CALIFORNIA DIVISION OF MINES AND GEOLOGY

Supplement # 3 to

Fault Evaluation Report FER-13

Name of fault: Ventura fault.

Fig. 3. Index map showing location of seismograph stations, selected major faults, and geomorphic provinces with respect to the Santa Barbara Channel region (boxed area). (From ~~Vedder, 1973~~, Lee and Vedder, 1973, p. 1758.

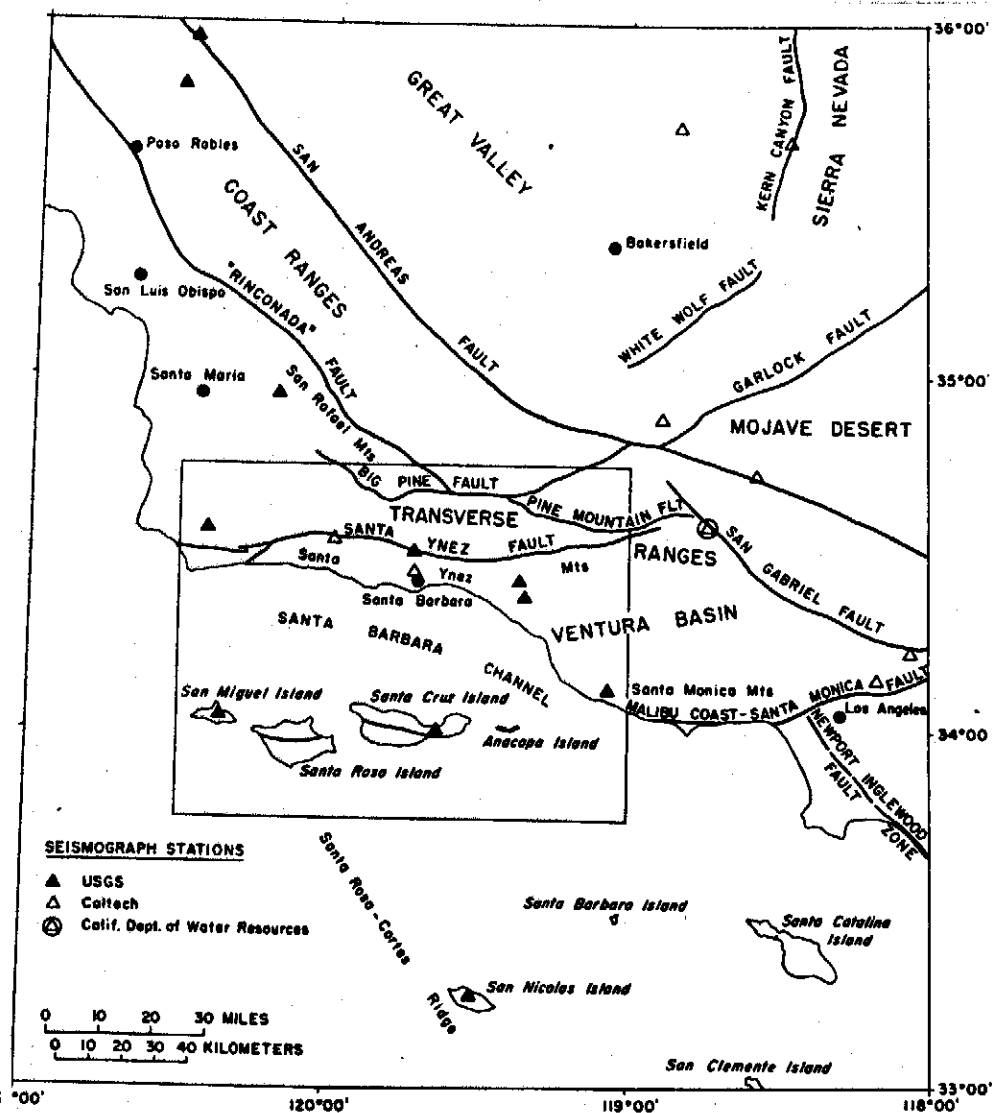
Again, both Geotechnical Consultants (1977) and Sarna-Wojcicki, et al. (1976) at least agree that reverse movement is indicated by local epicenters. However, it should be noted that Geotech cites Hilesman, et al. (1973) of Cal Tech while Sarna-Wojcicki, et al. cite Lee and Vedder (1973) of U.S.G.S. The U.S.G.S. has a much ^{denser} ~~lessor~~ and more closely

located network of seismographs (figure 3). Lee and Vedder noted significant differences between the locations of the same 25 earthquakes as determined by the two teams (figure 4). It is logical to consider the U.S.G.S. locations (and their ^{derivation of the} senses of displacement) as the better data.

FIGURE 5.—Plan and profiles of trace of fault 0.9 km north of mouth of Lopez Canyon, based on planetable mapping. For location see figure 2. Elevations on profiles referred to local assumed datum. Numbers preceded by S are field survey stations. (From Bonilla, et al., 1971, p. 69).

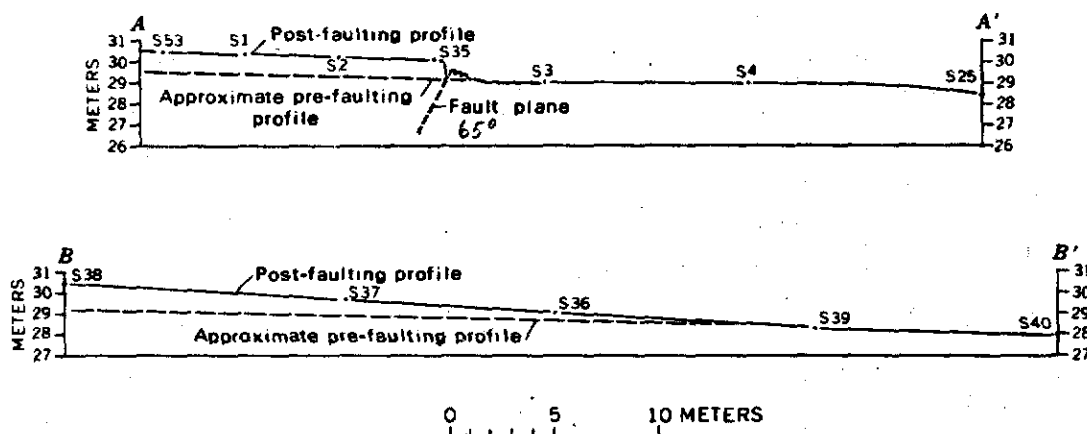
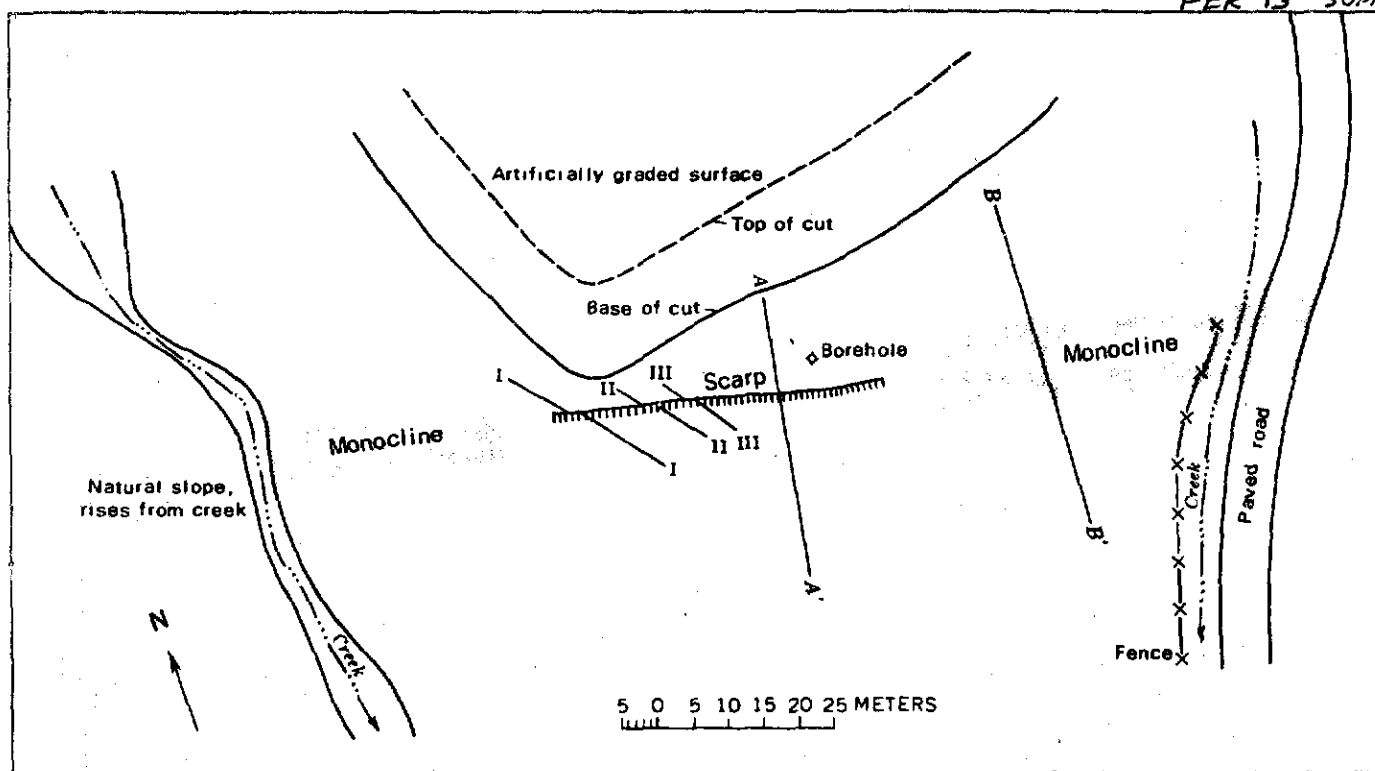
One could argue whether the Ventura fault is actually a fault or a monocline. At the surface it is a monocline. More precisely, it is a faulted monocline, and has apparently been uplifted and faulted during the Holocene. During the 1971 San Fernando earthquake, near Lopez Creek a case was noted where a fault "died out" at either end in a monoclinial fold (Bonilla, et al., 1971; see figure 5). The implications are

obvious. However, the State Geologist, rather than zoning ^{on the basis of the presence of} an "active monocline" should definitely zone the active faults that occur on the monoclinial fold. Geotechnical Consultants (1977, p. 17), although refraining from calling these faults "faults" (they called them "soil fractures" and stated that these fractures exhibited offsets -- by dictionary definition what they describe are faults) at least recognized that critical structures should not be placed over them.
